**TOWNSHIP OF SOUTH FRONTENAC
Committee Of Adjustment Meeting
Agenda**

TIME: 7:00 PM,
DATE: Thursday, October 13, 2022
PLACE: Council Chambers/Virtual via Zoom.

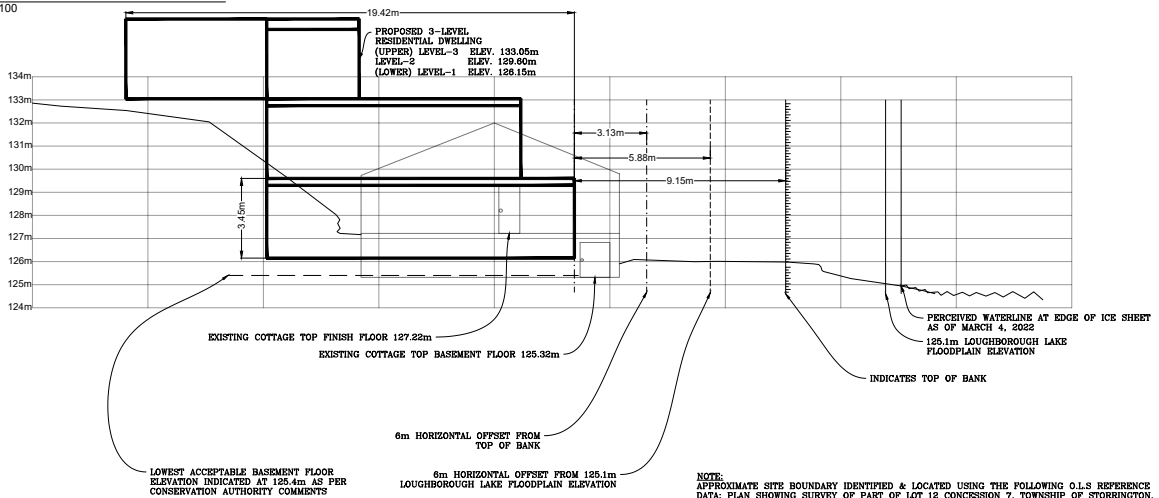
No.	Description	Date
01	PRELIMINARY	2022/03/15
02	REVISED AS PER ARCH. DRAWINGS	2022/04/19
